SUBJECT: Indian Point 3 Nuclear Power Plant
Docket No. 50-286
**Supplement to Proposed Change to Technical Specifications Regarding
Post Accident Monitoring Instrumentation**

ENTERGY RESPONSES TO NRC REVIEWER COMMENTS

PROPOSED TECHNICAL SPECIFICATION CHANGES REGARDING POST ACCIDENT MONITORING INSTRUMENTATION

**MARKED PAGES FOR THE PROPOSED
TECHNICAL SPECIFICATION CHANGE REGARDING
POST ACCIDENT MONITORING INSTRUMENTATION
FOR INFORMATION ONLY
(includes proposed changes to Bases)**

INSERT FOR BASES PAGE B 3.3.3 -11:

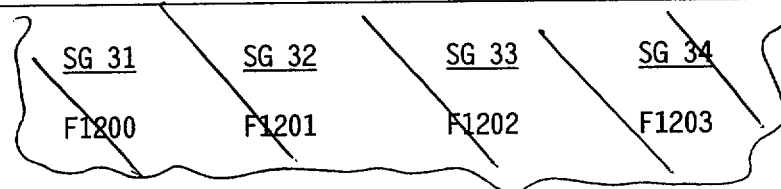
14. Steam Generator Water Level (Wide Range) and Auxiliary Feedwater Flow

Each steam generator has one level transmitter that spans a range from the tube sheet up to the moisture separator. Wide range SG water level is a Category I, Type A variable used to determine if the SG's are being maintained as an adequate heat sink for decay heat removal. Since there is only one instrument channel per steam generator, Auxiliary Feedwater (AFW) flow instrumentation is credited for providing a redundant means of determining if adequate decay heat removal by the SGs is being maintained. Although not a category I or Type A variable for IP3, the AFW flow instrument channels provide redundancy for SG wide range level in the event of the limiting single failure of a power supply. The LCO requirement for this function is satisfied by one SG wide range water level channel and one AFW flow channel for each steam generator. The instrument channels for SG wide range water level are designated LT-417D, LT-427D, LT-437D, and LT-447D. The instrument channels for AFW flow are designated F1200, F1201, F1202, and F1203.

15. NOT USED
